# Access Compliance Report

## Public Rights-of-Way

Intersection ID: 30443	Main Street: CADES_COVE_DR	Cross Street: ELM_BEND_DR	Location:	N
ADA ID: 2709BFFFFB47E	Ramp Type: PerpDiag	Initial Pass/Fail: Fail	Overall Compliance: No	Severity Score: 12.5

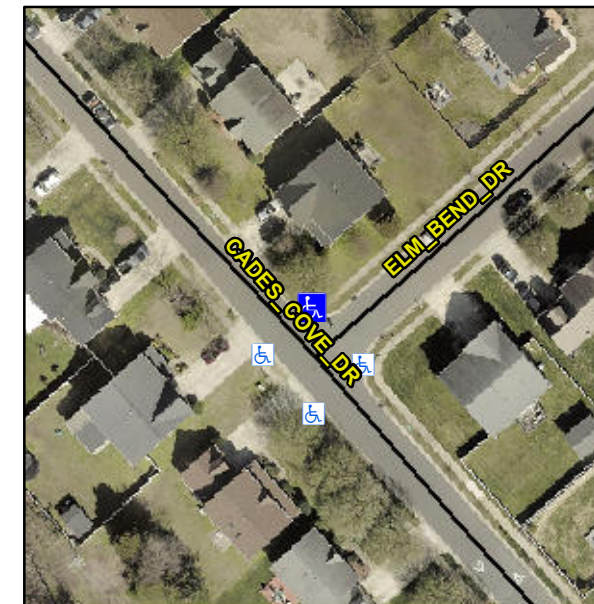
**R304.5.3**

Compliance	Description	Data	Compliance	Description	Data
N/A	Ramp Length (in)	46.0	Yes	Ramp Slope (%)	6.9
Yes	Ramp Width (in)	48.0	No	Ramp XSlope (%)	6.2
N/A	Flare Type LT	N/A	N/A	Flare Type RT	N/A
N/A	Flare Slope LT (%)	N/A	N/A	Flare Slope RT (%)	N/A
N/A	Flare Traversable LT?	N/A	N/A	Flare Traversable RT?	N/A
N/A	Landing Length (in)	N/A	N/A	DWS Provided?	N/A
N/A	Landing Width (in)	N/A	N/A	DWS Contrast?	N/A
N/A	Landing Slope (%)	N/A	N/A	DWS Length (in)	N/A
N/A	Landing X Slope (%)	N/A	N/A	DWS Full Width?	N/A
N/A	Landing Curb? (Y/N)	N/A	N/A	DWS Offset (in)	N/A
N/A	Shared Landing?	N/A			
N/A	Gutter Ponding?	N/A	N/A	Gutter Slope (%)	N/A
N/A	Gutter Lip Ht (in)	N/A	N/A	Gutter X Slope (%)	N/A
N/A	Painted X Walk1?	No	N/A	Painted X Walk2?	No
	X Walk 1 Direction	To SW		X Walk 2 Direction	To SE
N/A	X Walk 1 Width (in)	N/A	N/A	X Walk 2 Width (in)	N/A
	X Walk 1 Slope (%)	3.4		X Walk 2 Slope (%)	0.1
	X Walk 1 X Slope (%)	1.2		X Walk 2 X Slope (%)	1.9

**Remove & Replace Curb Ramp With Two New Directional Ramps or Equivalent.**
